)	
In the Matter of	)	
SOUTHERN CALIFORNIA EDISON COMPANY)	)	Docket Nos. 50-361-CAL & 50-362-CAL
(San Onofre Nuclear Generating Station,	)	
Units 2 and 3)	)	January 28, 2013
	)

Subject: **Docket No. 50-361  
Response to Request for Additional Information (RAI 1)  
Regarding Confirmatory Action Letter Response  
(TAC No. ME 9727)  
San Onofre Nuclear Generating Station, Unit 2**

RESPONSE TO REQUEST FOR ADDITIONAL INFORMATION

REGARDING RESPONSE TO CONFIRMATORY ACTION LETTER

Figure 2 – Typical Stabilizer Deployment to Arrest Retainer Bar Wear

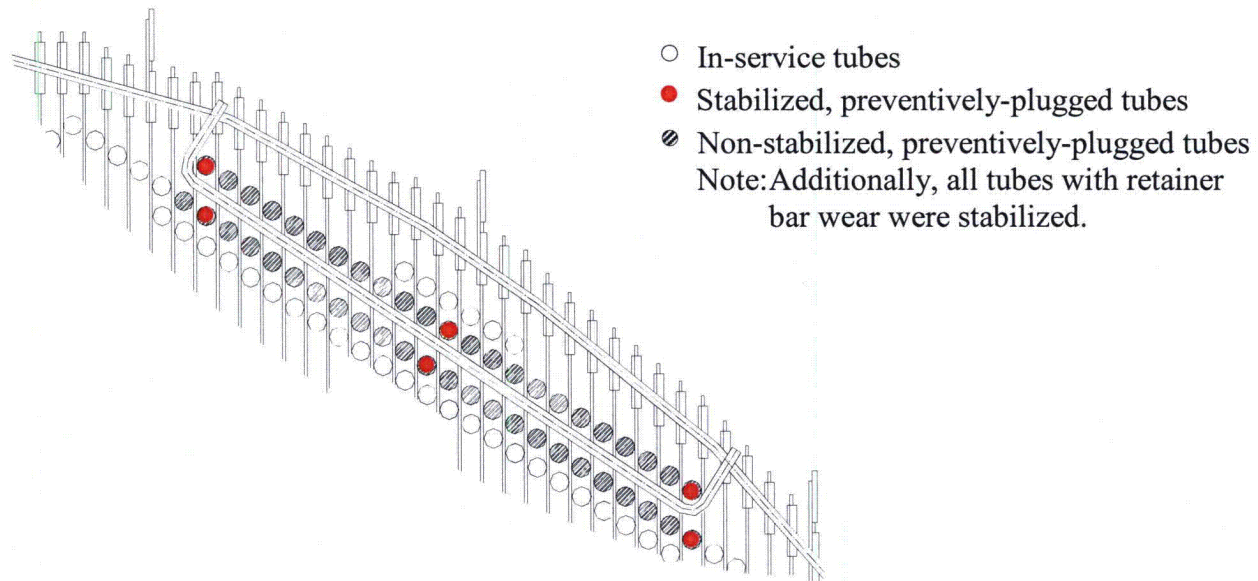
Additionally, stabilizers have been deployed in six tubes at each retainer bar. Figure 2 shows a typical deployment. Three tubes on each side of the retainer bar have been stabilized: one tube near the center of the retainer bar and two tubes near both ends of the retainer bar. The stabilizers will arrest tube wear at the wear surface of the stabilizers. Since the tubes adjacent to retainer bars have no evidence of significant vibration and the retainer bar vibration amplitude is limited, the stabilizer deployment pattern prevents any possible retainer bar or tube displacement/wear geometry that could sever any of the tubes adjacent to the retainer bars.

The integrity of the non-stabilized, preventively-plugged tubes is ensured by the limited vibration amplitude of the tubes and retainer bars, along with the number and arrangement of stabilized, preventively-plugged tubes at each retainer bar.
